**SUBARU**

## SERVICE BULLETIN

**NUMBER:** 02-143-13R

**SUBJECT:** Surface Treatment Change To Oil Control  
 Piston Rings

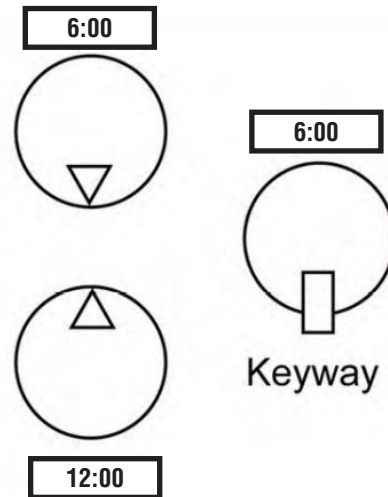
- **IMPORTANT:** After all 32 bolts securing the chain cover are removed, be **VERY** careful where you pry and what you pry on to break the silicone sealant bond. The photos below show an example of where NOT to pry. In this case, the cam cap became cracked requiring a complete cam carrier replacement. Patience is the key!

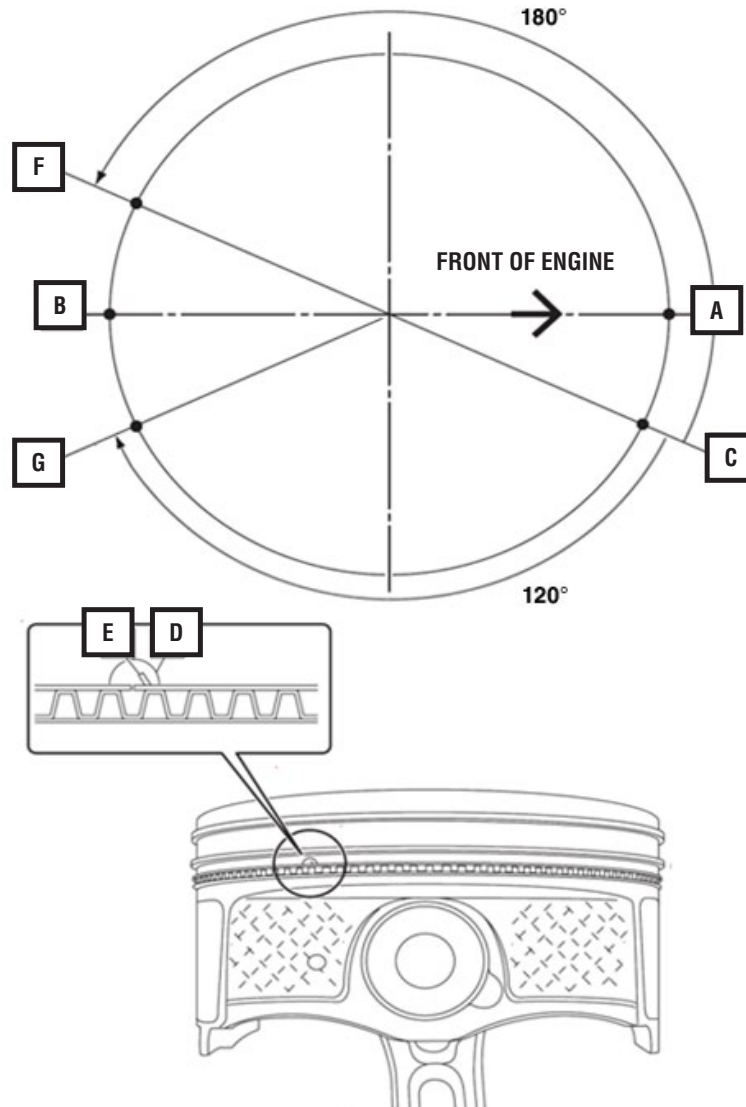
- “A”- Top compression ring end gap location
- “B”- Second compression ring end gap location (180 degrees away from “A”)
- “C”- Top oil control scraper ring end gap
- “D”- Recess in top of ring land to accept the “tang” of the upper oil control scraper ring - “E”
- “F”- Expander gap (180 degrees away from “C”)
- “G”- Bottom oil control scraper ring end gap (120 degrees away from “C”)
